## PCN – Process Change Notification

Change:	AP.25E.07.0062A.dp
Date:	2017/01/25
Author	Haley Tsai

Model#	Part Number	Changes
AP25E 1 Stage 15dB Antenna Assembly 62mm 1.13 IPEX MHF1 Saw Filter Tuned For Network Fleet	AP.25E.07.0062A.dp	Amend Dimensions

### Illustration of Change

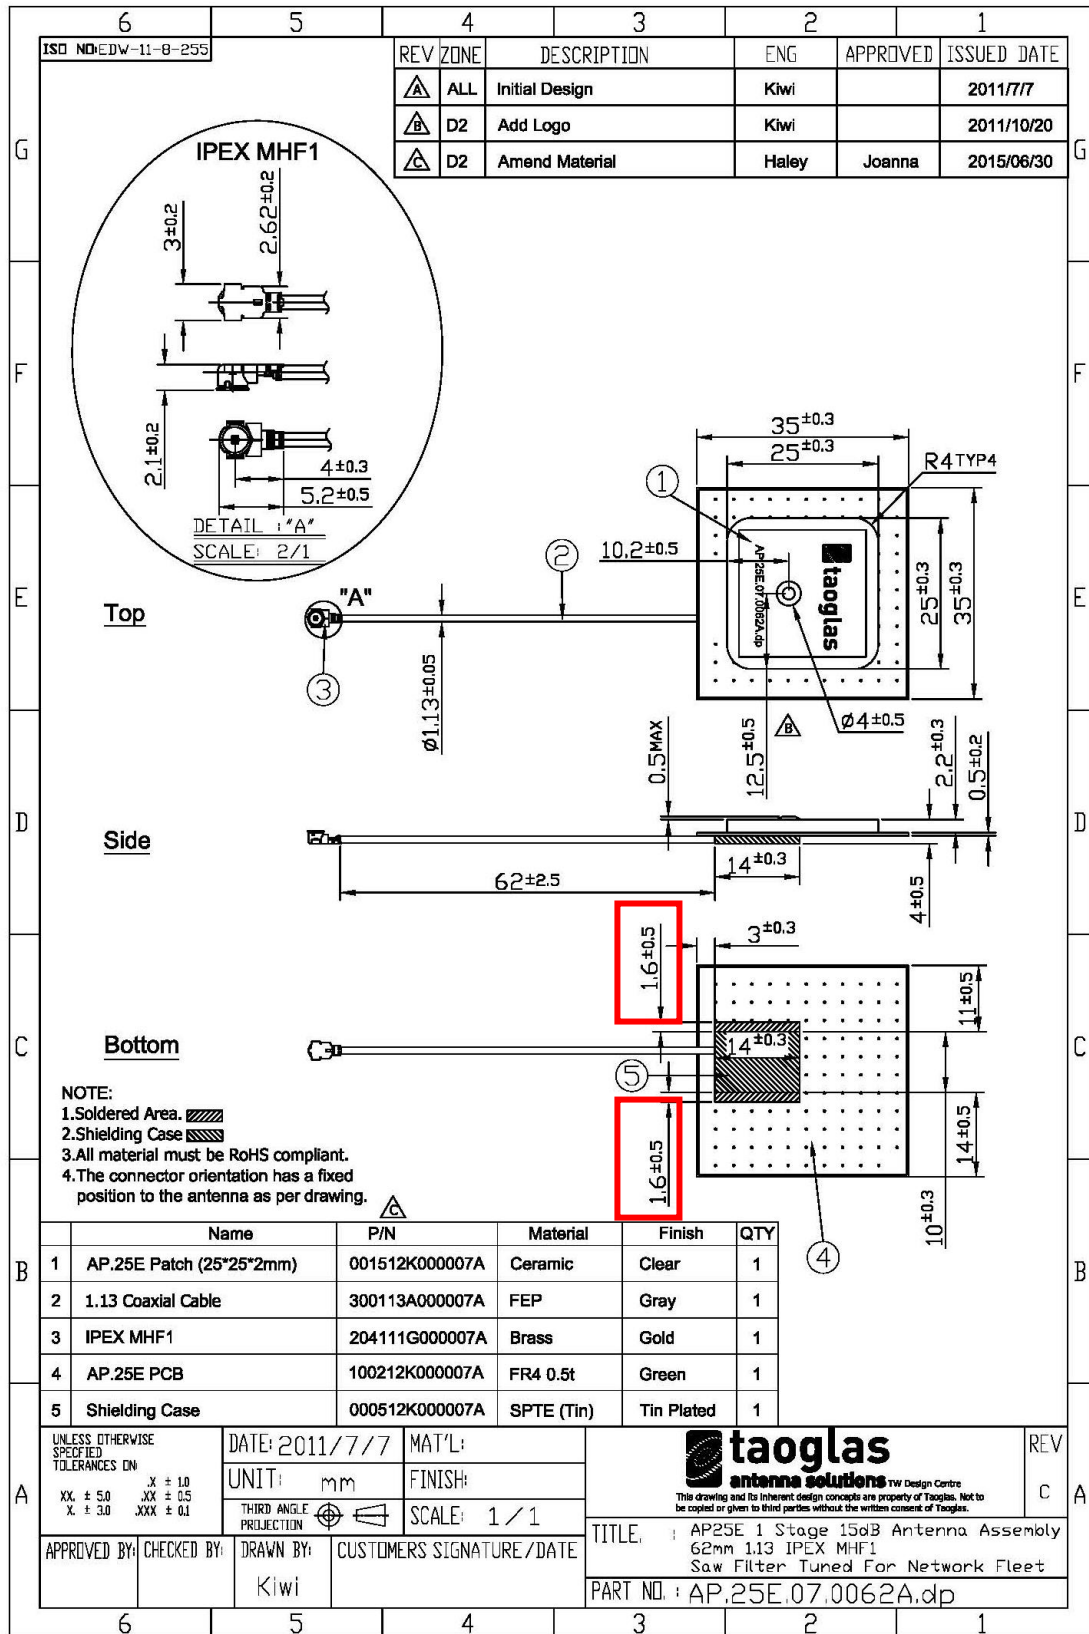
Dimensions for soldering pads on 1.6mm are out of spec ,so we corrected  $1.6\pm 0.5\text{mm}$  to  $1\pm 0.5\text{mm}$  to match the actual sample.
